BGEIGIEZEN V.3.0.3 ASSEMBLING ISSUES AND COMMENTS

Alberto Villa, 2024-07-03

3.2 - GPS module battery issue

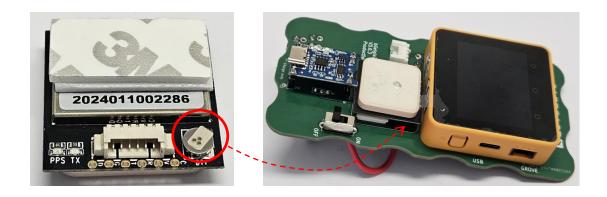
The GPS module has a small battery placed close to the holes for the header pins. This position is very near the M5 module, hence the substitution could be a difficult task without first removing the module from the board.

But the removal of the M5 module is impossible once the Geiger sensor is attached to the baseplate, because the two fixing screws are accessible only without the pancake in place.

Therefore the sensor should be detached from the baseplate, and I fear that this is not an easy operation (apart the risk of damaging the mica window).

4.2 – Issue with desktop pc and Windows 7

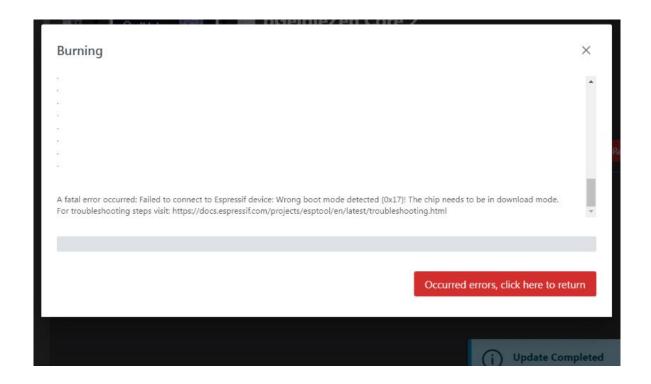
Tried also with a desktop pc running Windows 7 and several USB2 ports of type A. Again white screen of the M5 module, periodical rebooting and GPS blue led blinking. Now the COM port is detected and burning can be started. At the end it says "Update complete", but the display of the M5 module remains white and the following fatal error message appears:

Tried also after lowering the communication speed down to 115200 Baud, but without success.
